REMEDIATION SYSTEM EVALUATION

FORMER HONEYWELL FACILITY
FORT WASHINGTON, PENNSYLVANIA

Report of the Remediation System Evaluation,
Site Visit Conducted at the Former Honeywell Facility, Fort Washington, Pennsylvania
January 30, 2003

EPA 542-F-04-025
July 2003
www.epa.gov/tio
clu-in.org/optimization

FIGURE 4-2. POTENTIOMETRIC SURFACE MAP DEPICTING PUMPING CONDITIONS (1993).

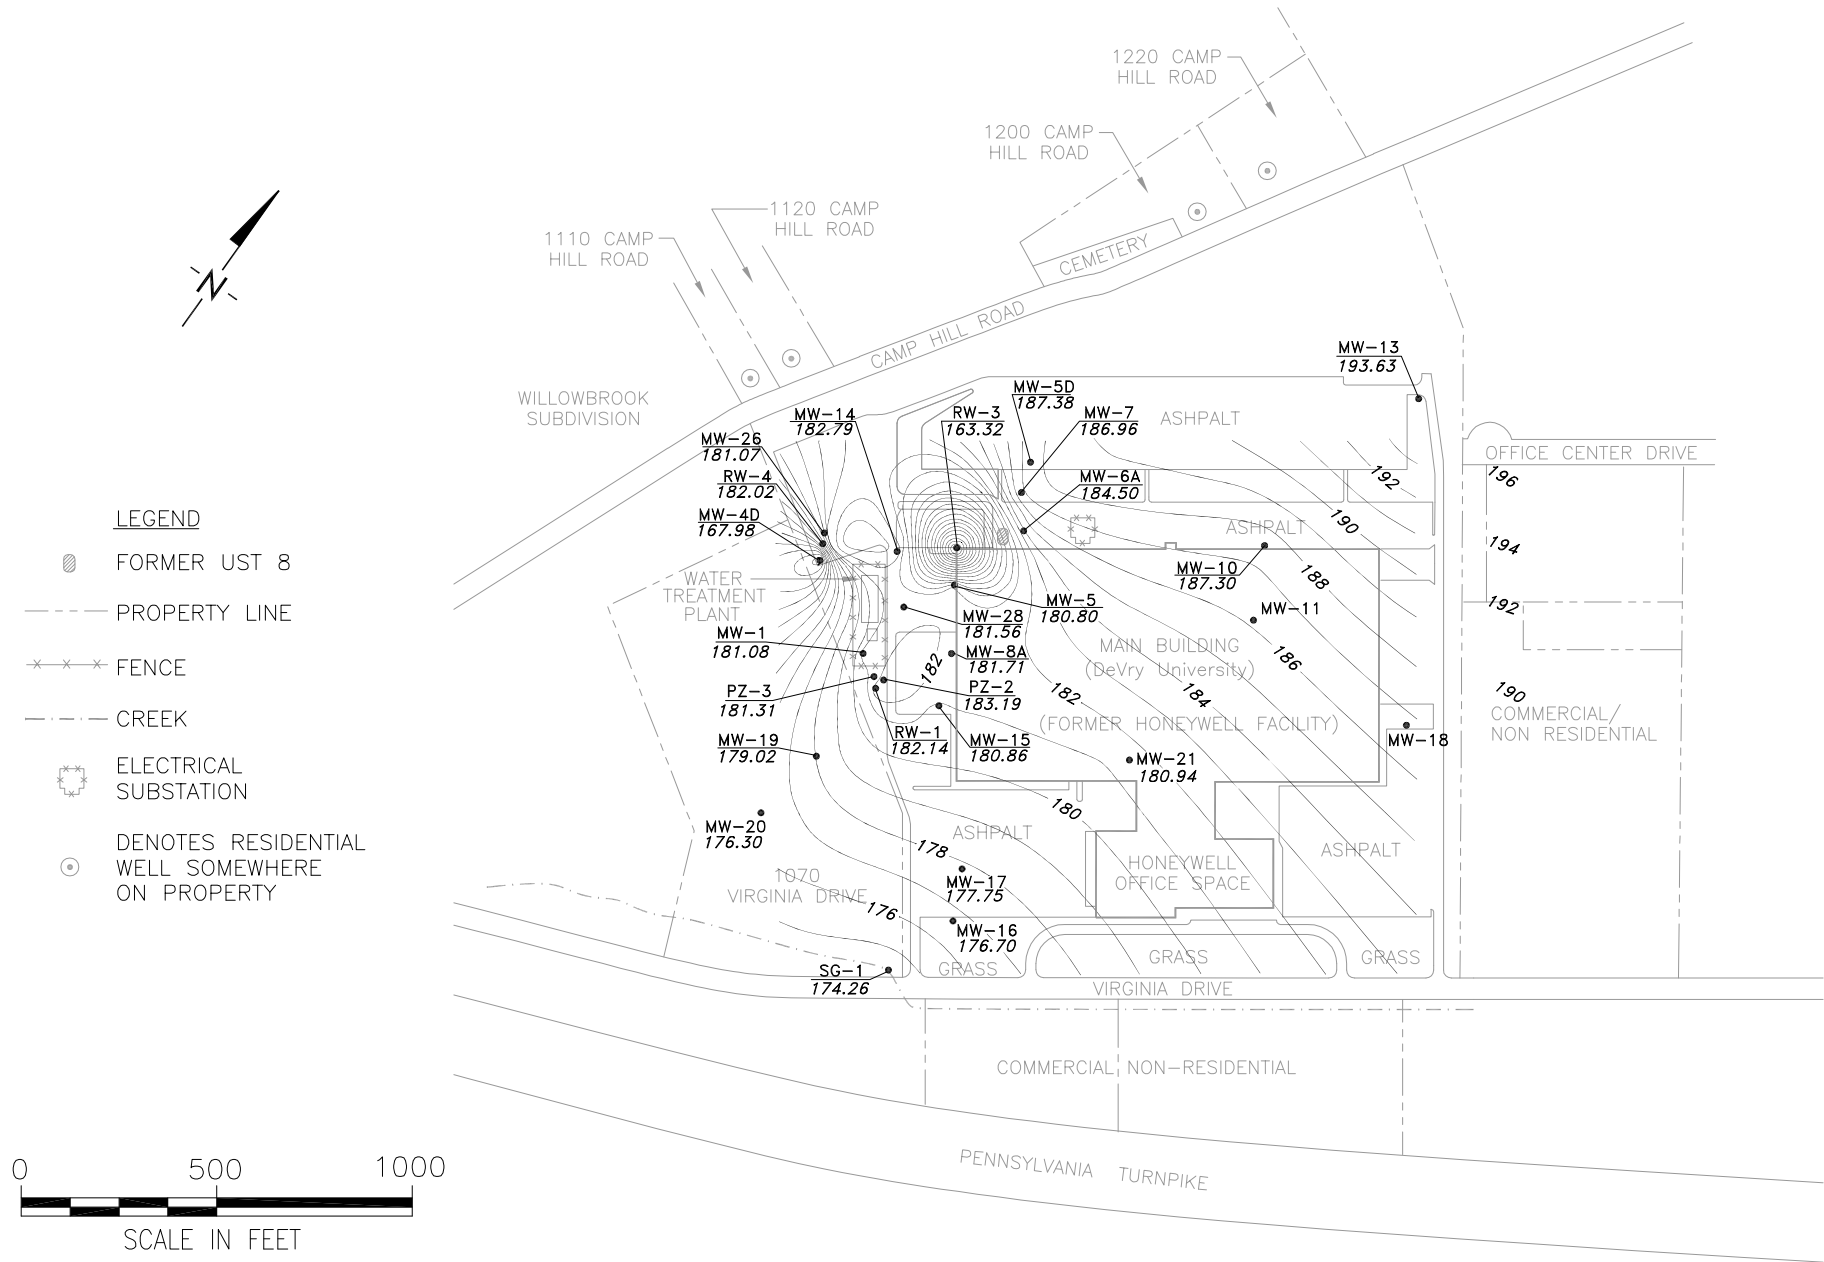
Potentiometric surface maps show an influence due to pumping, but as stated in Section 4.2.1, their development includes the use of water levels from operating pumping wells. As a result, the degree of drawdown and capture might be overestimated when using these potentiometric surface maps. Furthermore, as the *Draft Five-Year Review* indicates, the presence of complex geology with dipping beds and fracture orientations in three directions complicates analyses of ground water flow directions, particularly in Zone B.

Water levels should continue to be collected from all wells during sampling events, and potentiometric surface maps should continue to be developed. However, as stated in Section 4.2.1, the water levels from the operating wells should not be used when developing the potentiometric surfaces. Ideally, piezometers would be located near the extraction wells to provide a representative water level for the aquifer in those areas. Alternatively, the water levels from the extraction wells could be used if they are adjusted for well losses and the interpretation accounts for the likelihood that the drawdown is likely focused near the well (i.e., linear interpolation between the water level at the extraction well and other monitoring points is not necessarily a reasonable assumption). For this site, it is the opinion of the RSE team, that using corrected water levels from extraction wells is appropriate.
